Type No. **DMC-50747NF-AK**  
**LCD MODULE TECHNICAL NOTE**

Document Number **TN-DMC-50747-01**  
Revision **0.0**  
Date **2004/06/06**

# DMC-50747NF-AK TECHNICAL NOTE

Figure 1 -- Block Diagram of Power Supply

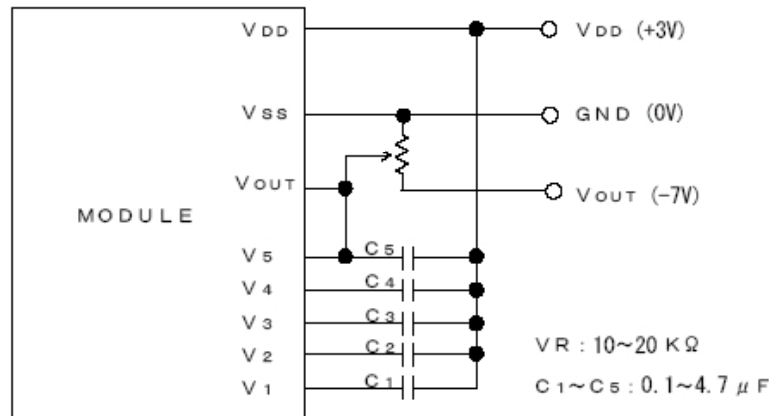
- 3.1. The Section 4.2 Example of Power Supply is not correct. Please refer to Figure 1 for the correct hookup. By varying the potentiometer, LCD contrast can be controlled. Please note that this setup is shown at the bottom of page 4-20 of reference (c) for the instance of 'External Power Supply.'

It is recommended to apply a potentiometer for the contrast adjust due to the tolerance of the driving voltage and its temperature dependence.

Both the boosting circuit and the voltage control circuit are not used in this module. Therefore, connect V5 pin with VOUT pin and supply the LCD driving voltage from the outside.
